Project Title: The 14 East City Drainage #: K13/D50

Re: The 14 East
Grading and Drainage Plan
Engineer's Stamp Date 1-15-2014 (K13/D050)

From: Biazar, Shahab
Sent: Friday, January 10, 2014 4:27 PM
To: "Jon Niski' (JNiski@tierrawestllc.com)'
Cc: Sims, Timothy E.
Subject: Hydrology comment and markup for The 14th East (K13/D50)
Attachments: K13D050_shahab_markups_2014JAN10.pdf

THE 14TH EAST
14TH AND COAL
GRADING AND DRAINAGE PLAN

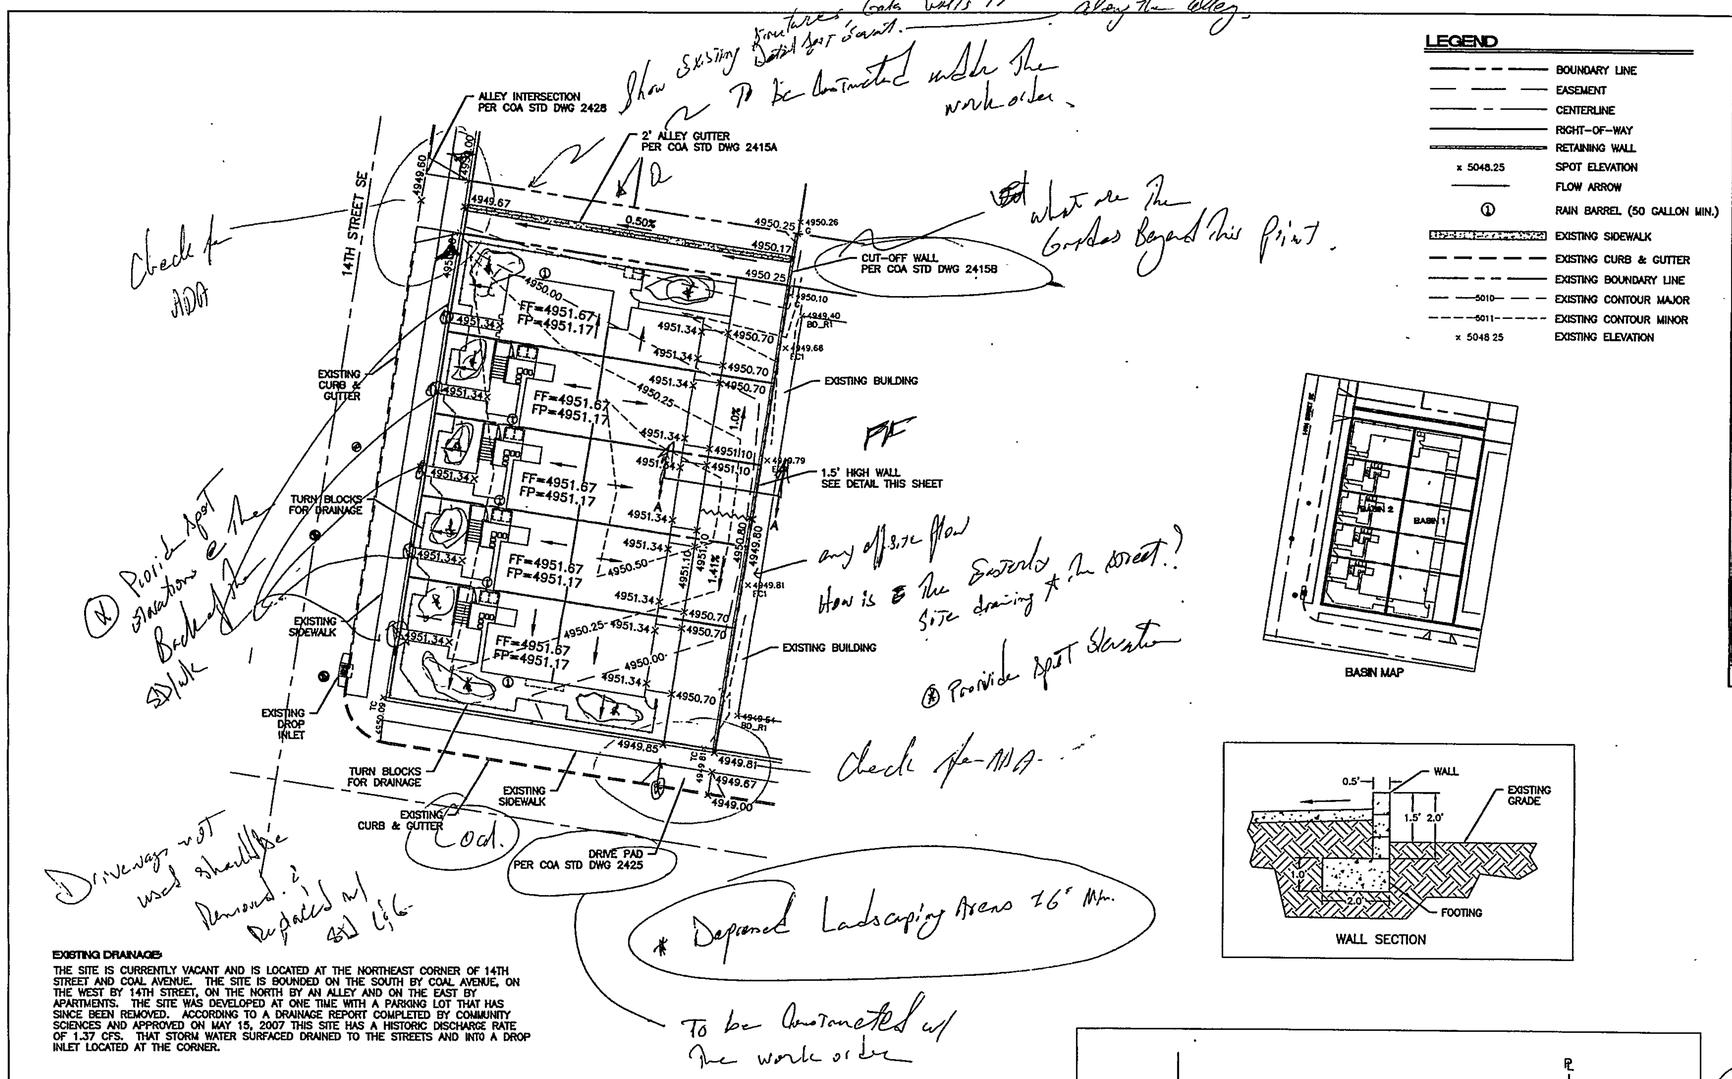
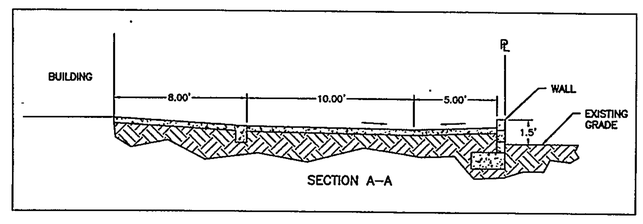
_ Depress all the landscaping areas where possible (6" min.).
_ All the driveway not used should be removed and replace with standard curb and gutter.
_ Provide additional spot elevations along the existing sidewalk on 14th Street to assure ADA requirement are met were new connections are being proposed from the new buildings. Also check the ADA grades at the proposed driveways.
_ Include the Coal Street name on the Plan and provide a City Bench Mark.
_ Show more spot elevations along the alley to assure the runoff and gates/entrances are not being blocked with the proposed alley improvements. Show all the existing improvements.
_ How does the alley drain to the east (Show additional elevations to the east).
_ Is there any offsite runoff from the east. There are roof gutters from the existing buildings that drain to the west.
_ Fix Section A-A.
_ All the removal and replacement of the existing driveways, new driveways/sidewalks, and Alley improvements should be constructed under the City Work order.
